TO: *mf* Marco Foster, MS473 54
THRU: *TRM* T. Madden / K. Klingman, NB82-230
FROM: *PF* P. Fuller / S. Beadle, NB 82-66
SUBJECT: C8 549
SR99, AWW Replacement North Access Connection
F.A. Project No: STPF-0099(122)
CHANGE ORDER 125
EN6, EN3A & EN3B Ductbank Changes

**WASHINGTON STATE
DEPARTMENT OF TRANSPORTATION
CHANGE ORDER**

CONTRACT NO: 008549 FEDERAL AID NO: STPF-0099(122)
 CONTRACT TITLE: SR 99, ALASKAN WAY VIADUCT - REPLACEMENT NORTH ACC
 CHANGE ORDER NO: 125 M-1, EN6, EN3A, EN3B DUCTBANK CHG

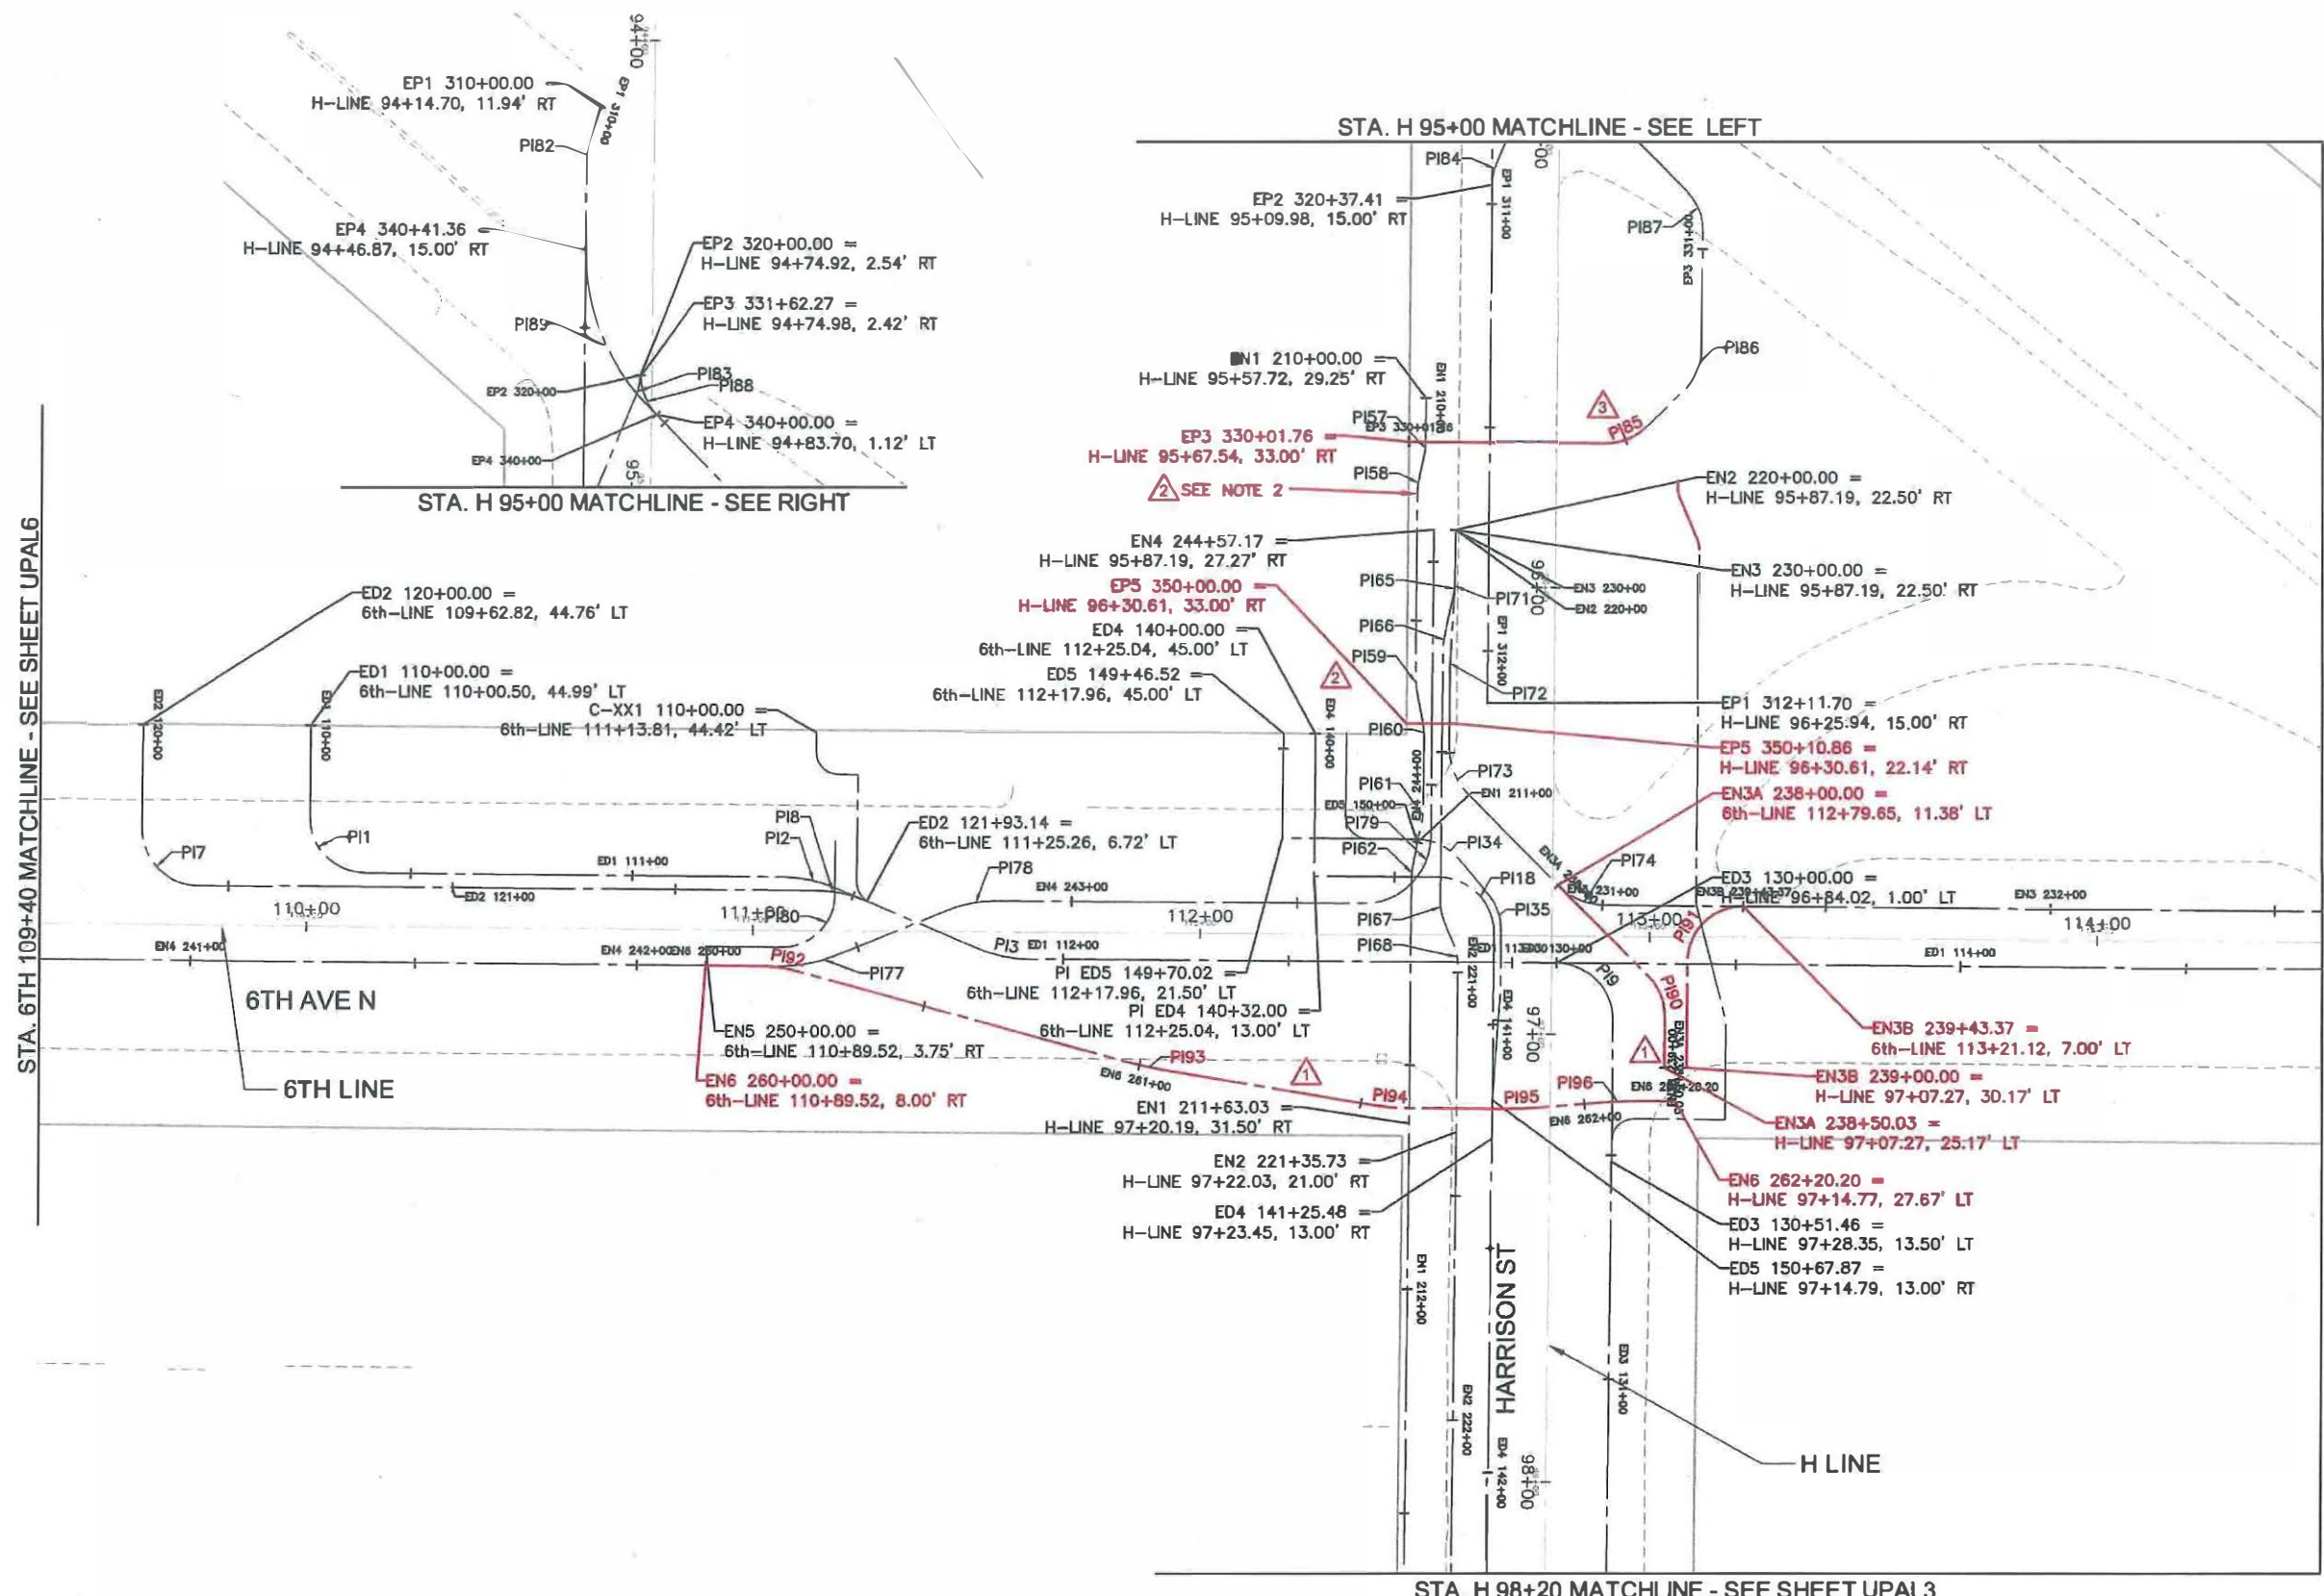
Adds new ductbank EN6 from station EN6 260+00.00 to 262+20.20 as shown on plans sheets UPAL1, UPT3, UP1, UP9, UP16, UPR2-UPR3, UPR7, UPR10A, UPD10, and UPD28. This work consists of excavation and shoring, procuring ductbank materials and installing them, placing high strength FTB, forming materials, setting forms and stripping, placing low strength FTB, chipping overpour at existing V-834, coring at V-834, dirt export and disposal, vactoring, dewatering the excavation area, 2ft overexcavation of trench and placing quarrying spalls and bedding, importing quarry spalls and bedding, supporting existing utilities which involves crossing live ductbanks at Harrison St. vicinity and supporting existing foundations, mobilization and demobilization of equipment, survey and cleanup.

Adds new ductbank EN3A from station EN3A 238+00.00 to 238+50.03 and adds new ductbank EN3B from station EN3B 239+00.00 to 239+43.37 as shown on plan sheets UPAL1, UPT3, UP1, UP9, UP16, UPR1, UPR9, and UPD10. This work consists of excavation and shoring, procuring ductbank materials and installing them, placing high strength FTB, forming materials, setting forms and stripping, placing low strength FTB, dirt export and disposal, vactoring, dewatering the excavation area, supporting existing utilities and existing foundations, mobilization and demobilization of equipment, survey and cleanup.

PLAN REF. NO.	UP9
SHEET	212
OF	770
SHEETS

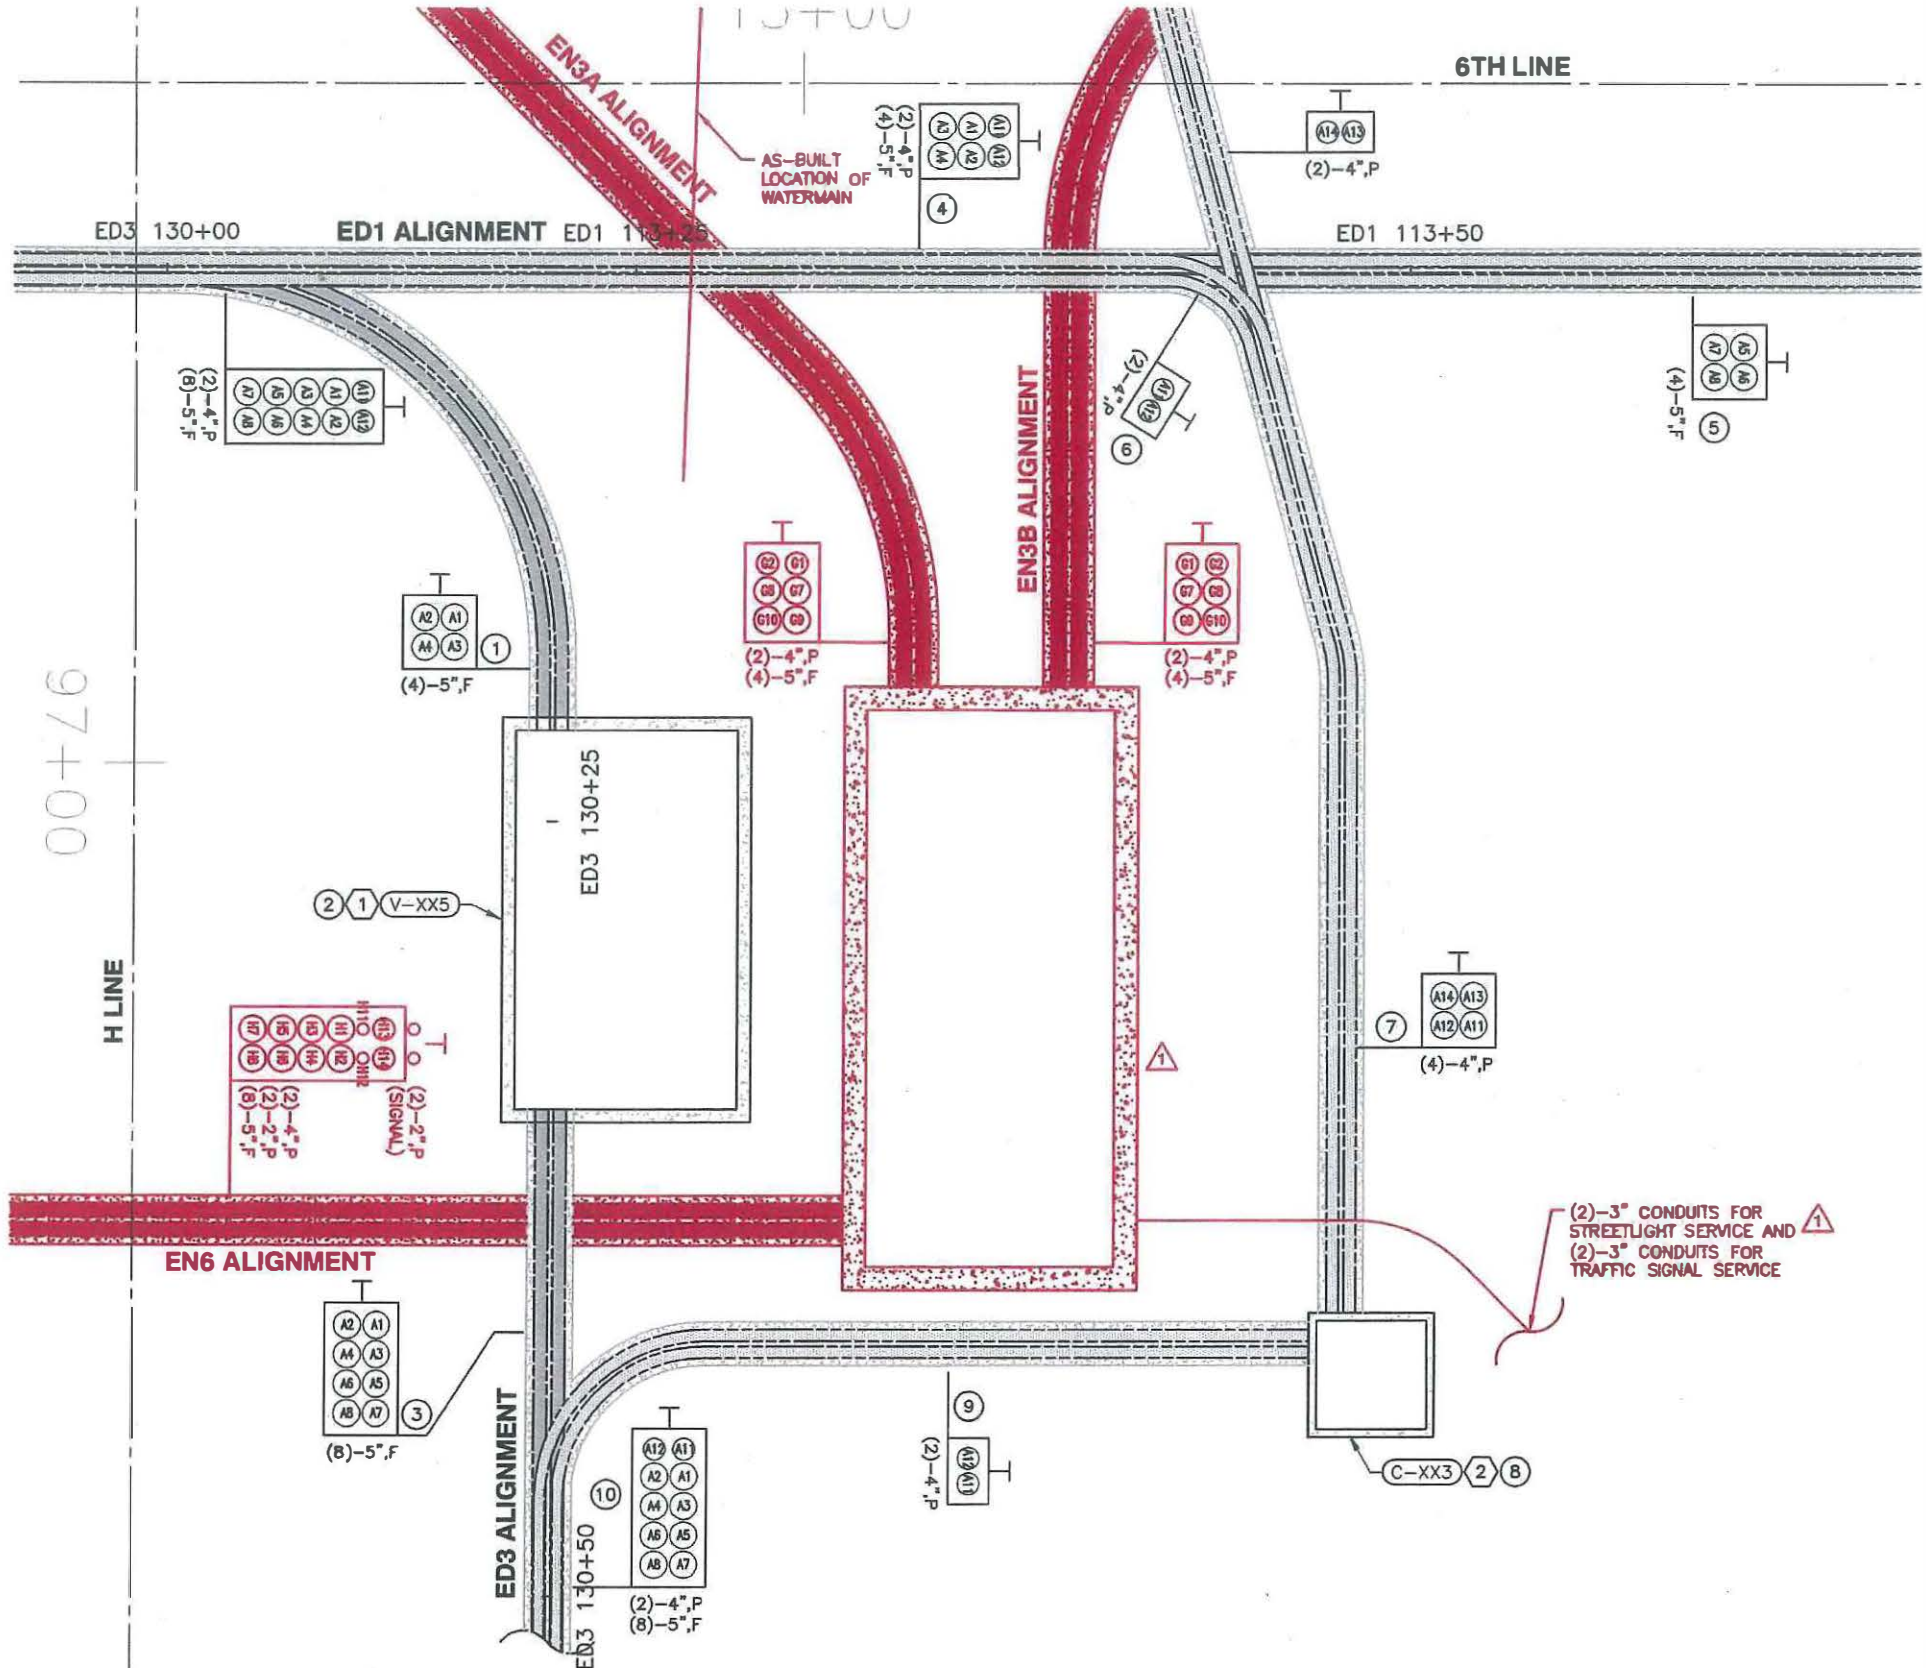
Adds the installation of the new M-1 vault at Station H-Line 97+07.27, (27.67' LT) as shown on UPN2, UP9, UP16, UPD19A, and UPD19B. The procurement and the shoring design of the M-1 Vault is included in C0150. This work consists of excavation, dirt export and disposal, vactoring, dewatering the excavation area, 2 ft. vault overexcavation and placing quarry spalls and bedding, importing quarry spalls and bedding, supporting in place vault V-XX5, removing C-XX3 vault and replace in kind, installing shoring system and procuring shoring materials, loading and unloading shoring system, setting the vault, mudding the vault, constructing a custom riser, removing shoring and backfilling, purchasing and placing CDF for backfilling, supporting existing utilities, mobilization and demobilization of equipment, survey and cleanup.

NEW SHEET

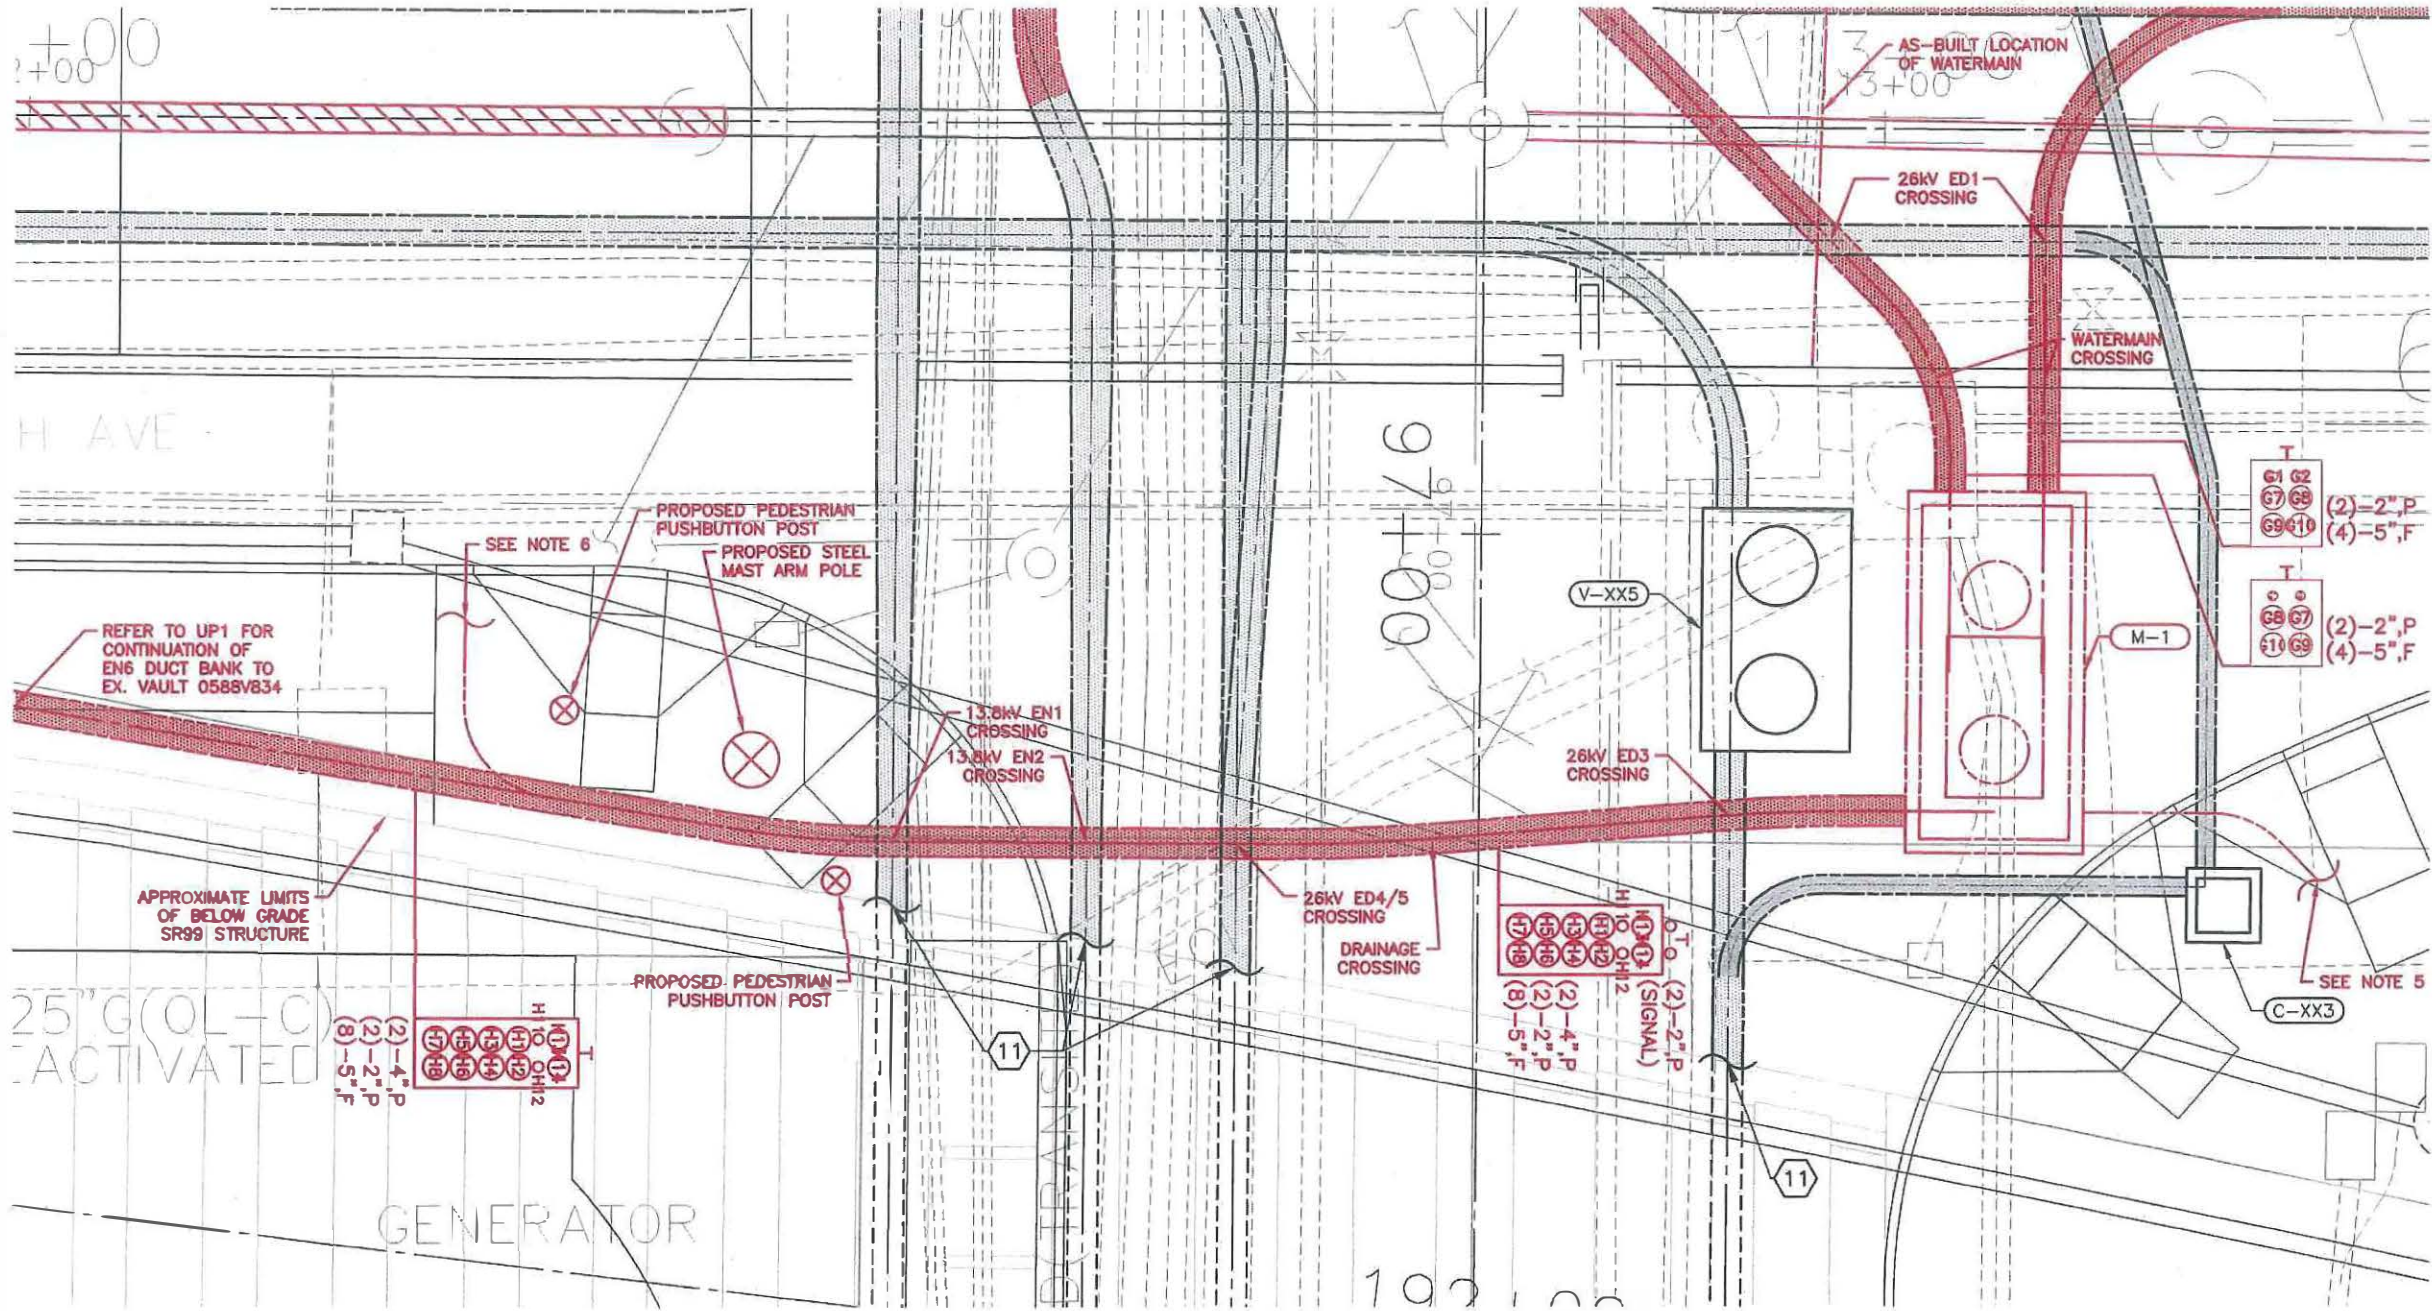
- REFER TO UP1 FOR DUCT BANK INFORMATION/ FLAGS FOR ALIGNMENTS OTHER THAN EN6.
